Reference: 24.014r04v04

Re: 40 Myoora Road, Terrey Hills
Council's Development Application No. DA2024/1362 (CNR-74738)
TfNSW Reference: SYD24/01792/03

Response to Request for Information

Figure 1: Intersection Priorities

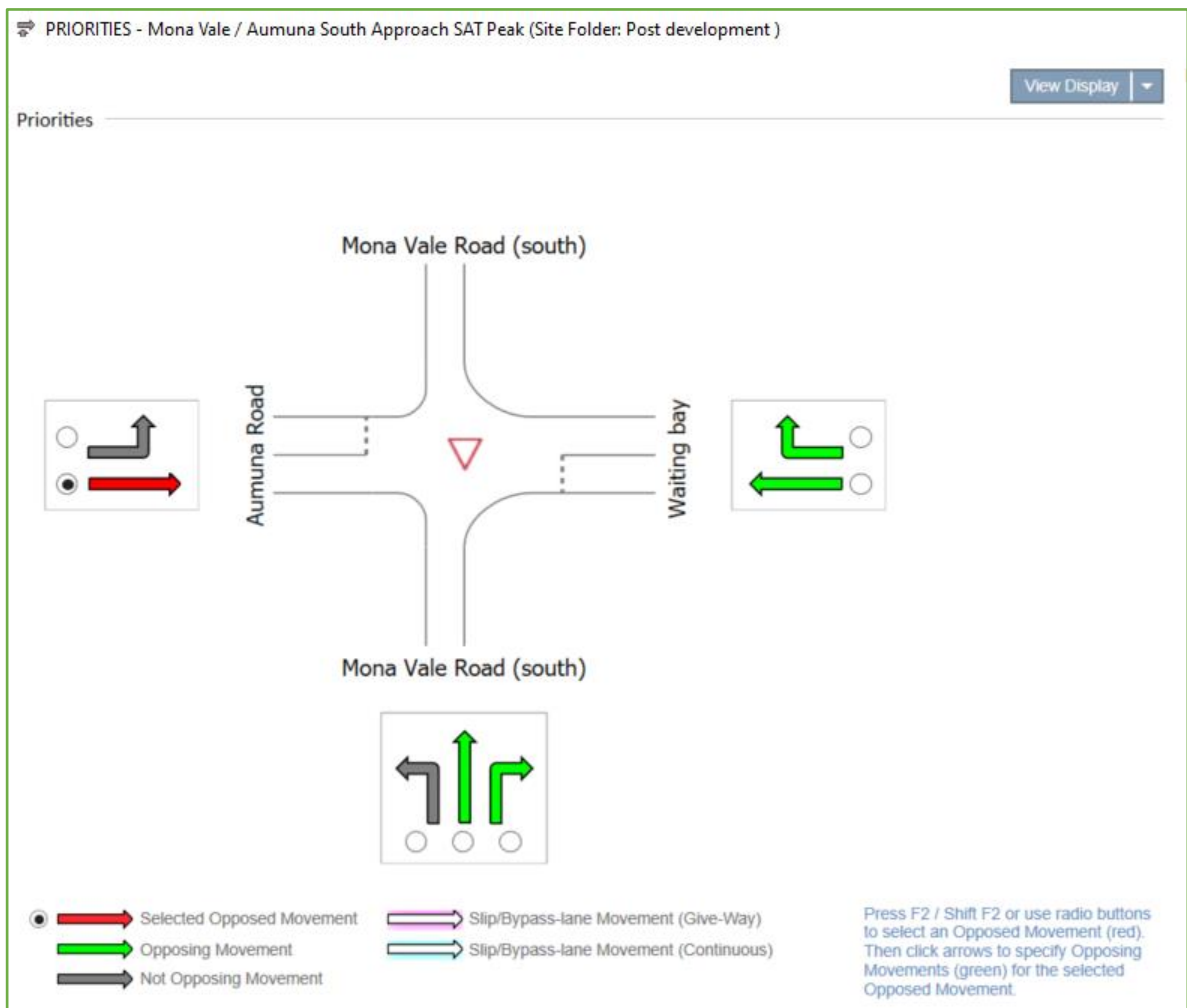
- a) *It appears that the through movement from Aumuna Road to the waiting bay is not giving way to the right turn volume southbound on Mona Vale Road right into Aumuna Road. The priorities in the SIDRA modelling only give way to the through movement and that has a total volume of 11 on the weekday and 3 on the Saturday. However, the volume is 28 on a weekday and 46 on a Saturday. It appears that the Applicant has not tested the right turn volume for vehicles turning into Aumuna and its impact on vehicles exiting Aumuna.*

1. Reference should be made to the extract in **Figure 1** below from the priority site input function in SIDRA for all scenarios showing the through movement from Aumuna Road to the waiting bay (red arrow) giving way to the right turn movement from Mona Vale Road southbound onto Aumuna Road, westbound (opposing green through arrow).

2. Notwithstanding, it does appear that vehicle movements were not linked between the right turn movement from Mona Vale Road, southbound to the through-movement from the waiting bay to Aumuna Road, westbound. This has been carried over from the original model, notwithstanding multiple revisions and reviews that have been made to the model since. The model has been revised accordingly, and a summary of the updated SIDRA results is provided in **Table 1** below. Reference should also be made to the updated SIDRA modelling results presented in **Attachment 2**.

Figure 2: Proposed New Mona Vale Road / Aumuna Road / Kamber Road Intersection Layout

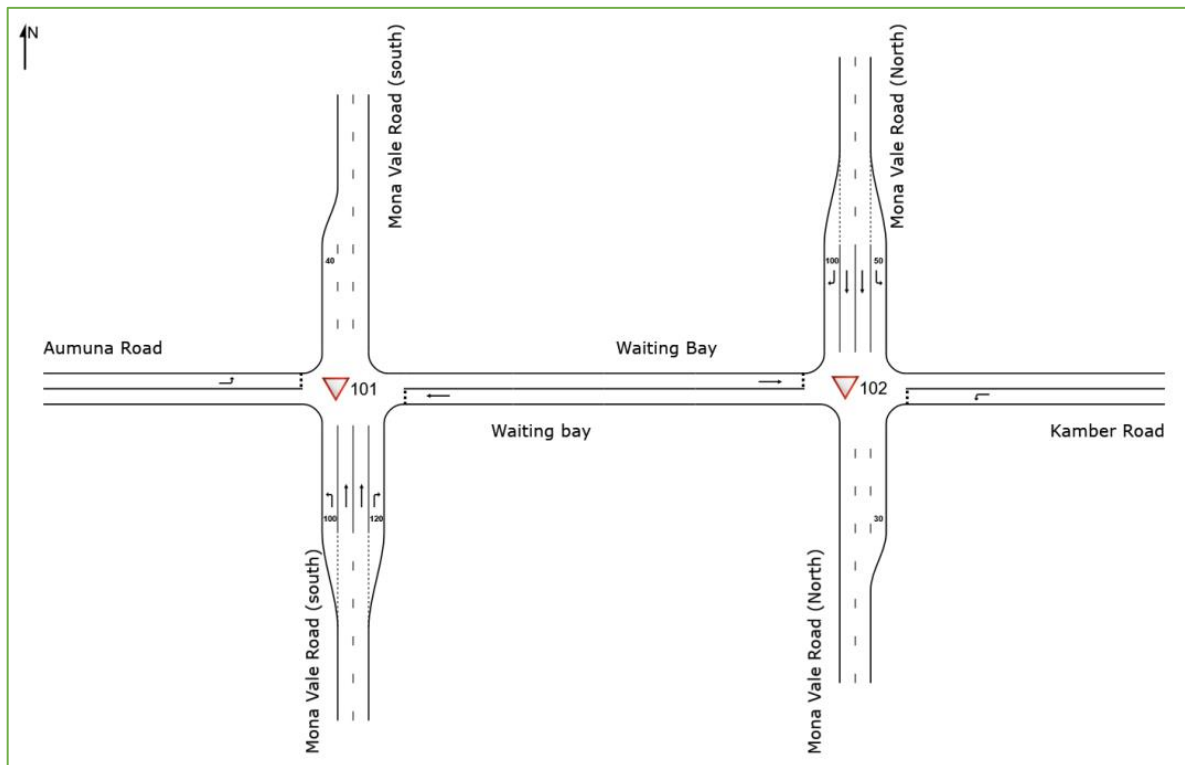
- a) *No transport or traffic amelioration measures are proposed by the Applicant at the intersection of Mona Vale Road (a classified road) and Aumuna Road to reduce the impact of the DA in terms of improving road safety and network efficiency outcomes that benefit the development's operations, the traffic it will generate and future road users. Should works be proposed, a strategic design will be required (refer to the TfNSW letter dated 12 November 2024 for additional details).*

6. An option which improves the performance of the intersection of Mona Vale Road / Aumuna Road / Kamber Road in relation to the existing and proposed scenarios involves the banning of right turn and through movements from Aumuna Road and Kamber Road onto Mona Vale Road in both directions. Reference should be made to the Concept Plan of the revised intersection layout presented in **Attachment 3** and to the proposed intersection layout shown in **Figure 2** below:

7. This option has been modelled for the proposed development scenario during the critical Saturday peak, the results of which are summarised in **Table 2** below. For clarity, the term 'Upgrades' referred to in the 'Scenario' column in **Table 2** below refers to the banning of right turn movements from Aumuna Road and Kamber Road onto Mona Vale Road.

Mona Vale Road / Aumuna Road / Kamber Road Intersection
Concept Design

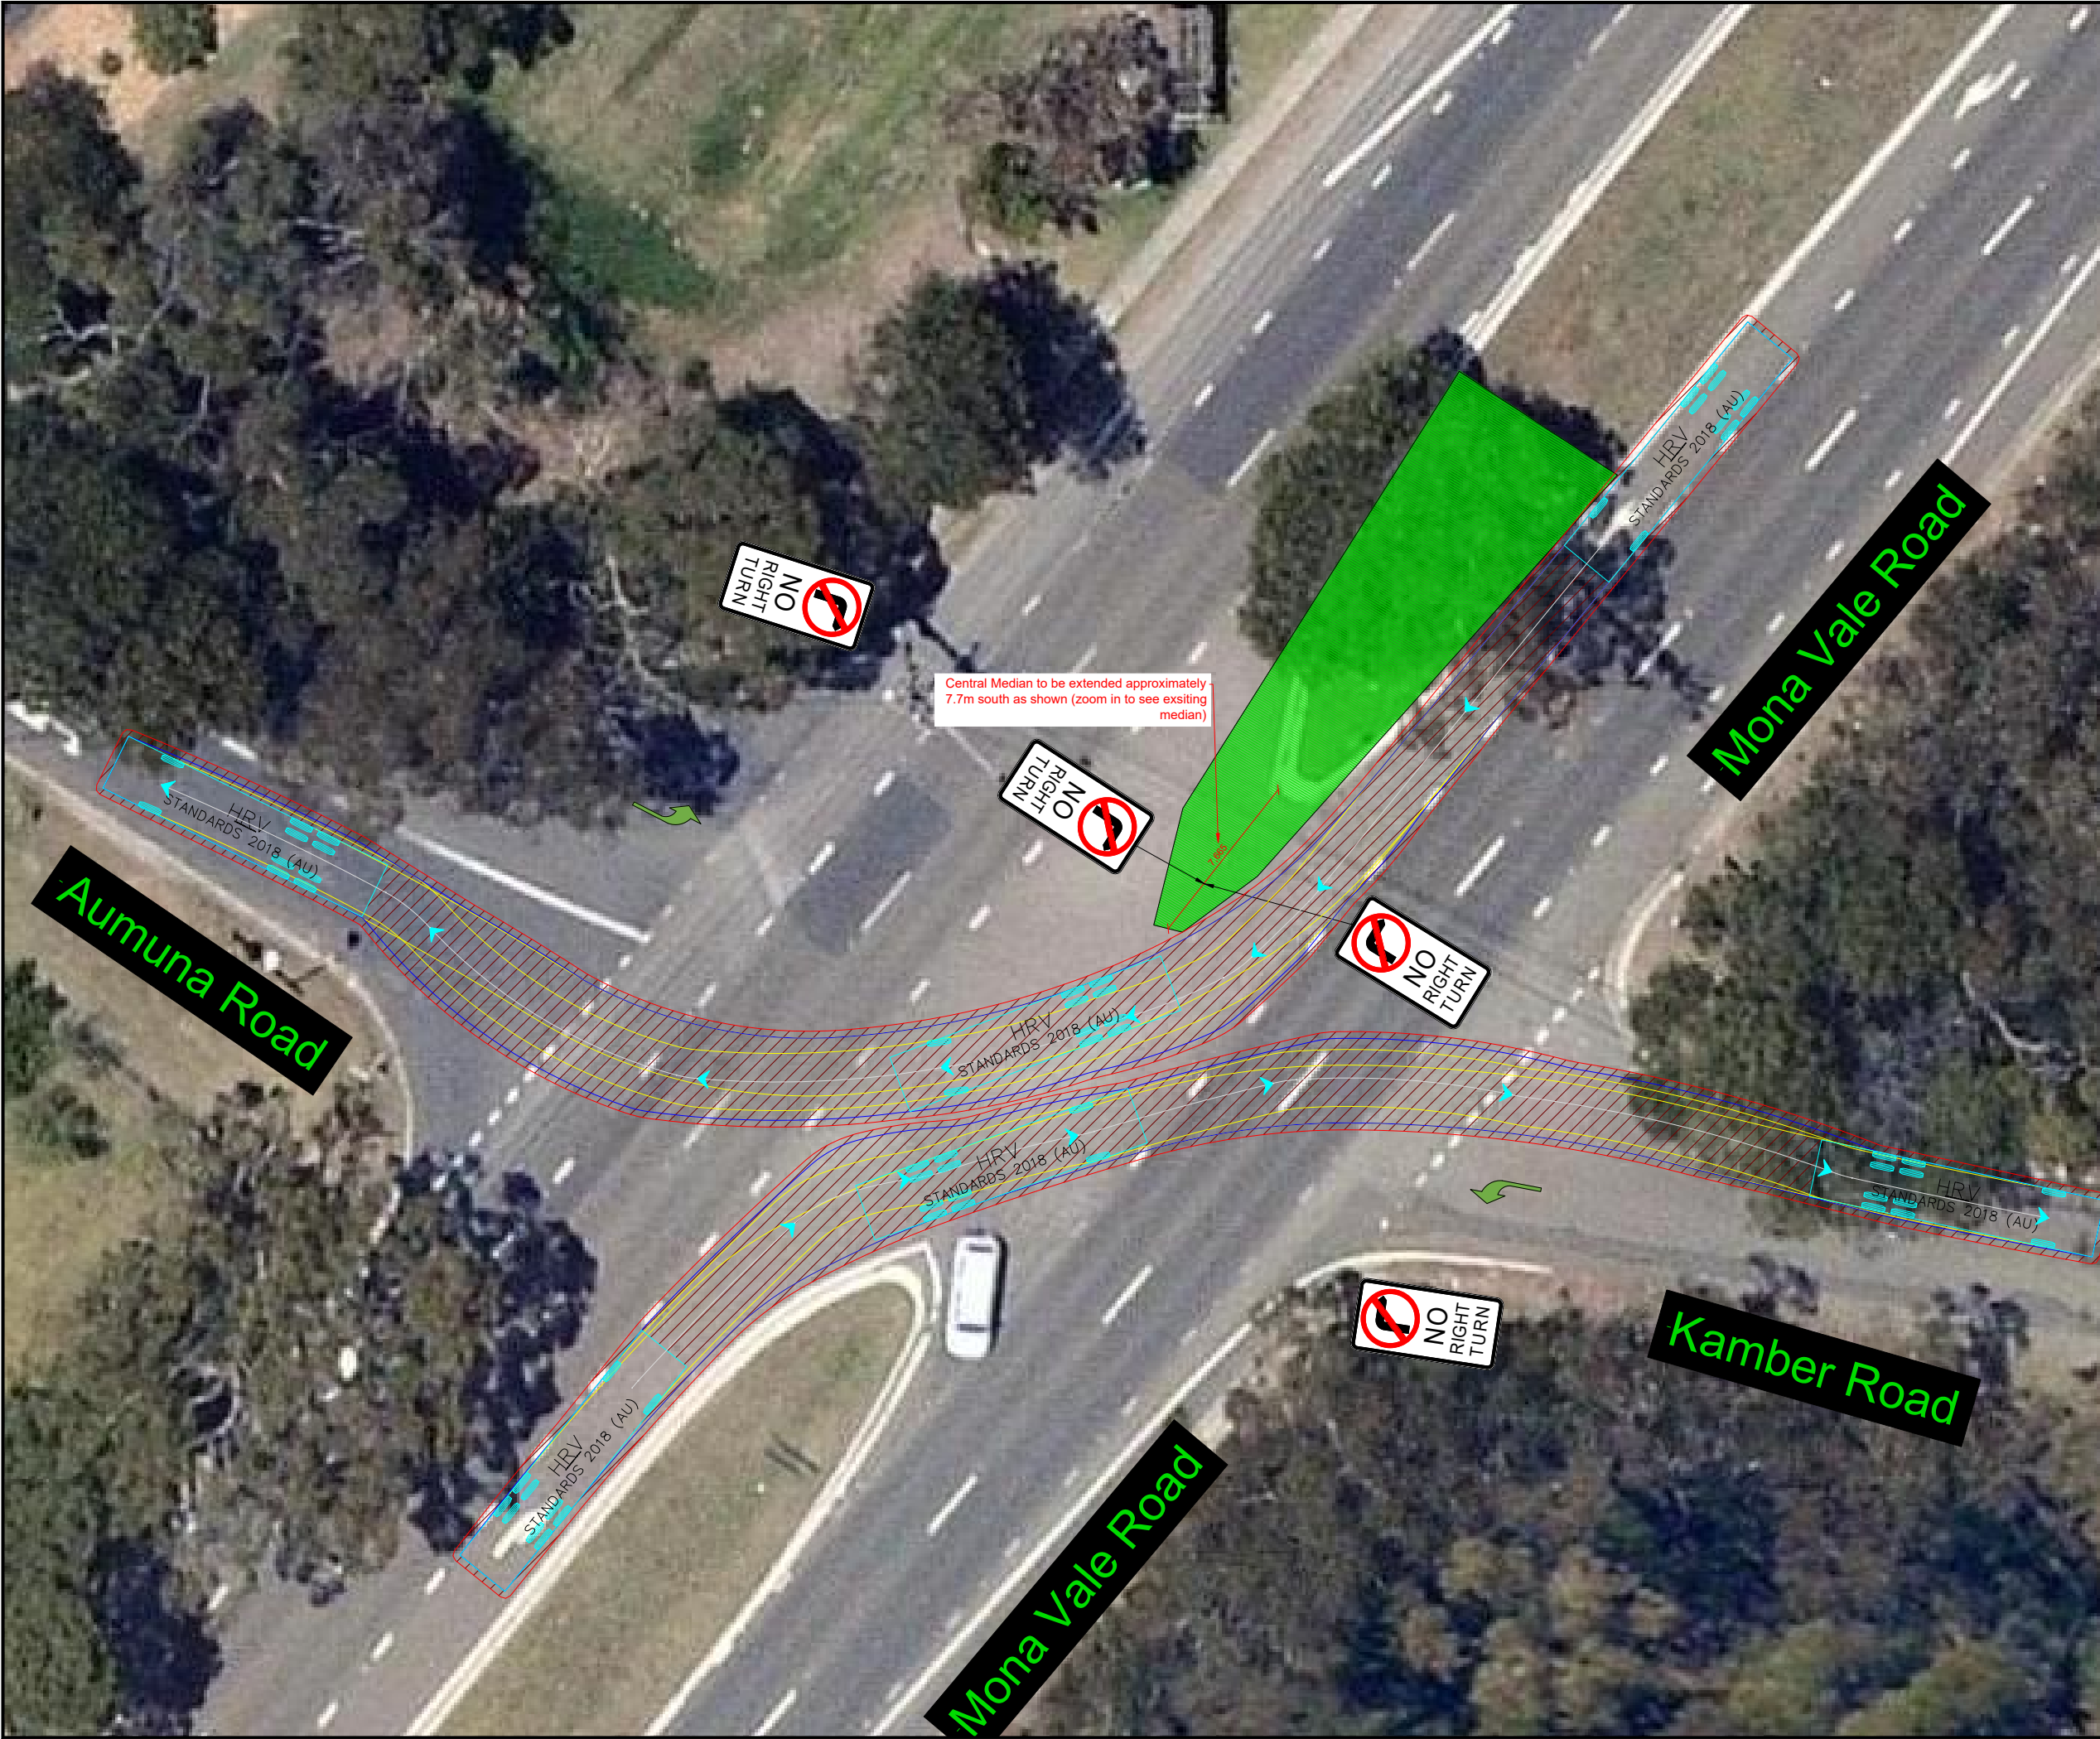
- a) No transport or traffic amelioration measures are proposed by the Applicant at the intersection of Mona Vale Road (a classified road) and Aumuna Road to reduce the impact of the DA in terms of improving road safety and network efficiency outcomes that benefit the development's operations, the traffic it will generate and future road users. Should works be proposed, a strategic design will be required (refer to the TfNSW letter dated 12 November 2024 for additional details).

Reference should be made to the mitigation measures discussed in response to Item 2 above. A Concept Plan showing the revised intersection layout of Mona Vale Road / Aumuna Road / Kamber Road as discussed above is provided in **Attachment 3** for reference. Prior to proceeding with an extensive strategic design exercise which would need to be prepared by a Civil Engineer and agreed upon between TfNSW and Council, it first needs to be established whether TfNSW would support the mitigation measures proposed above in principle.
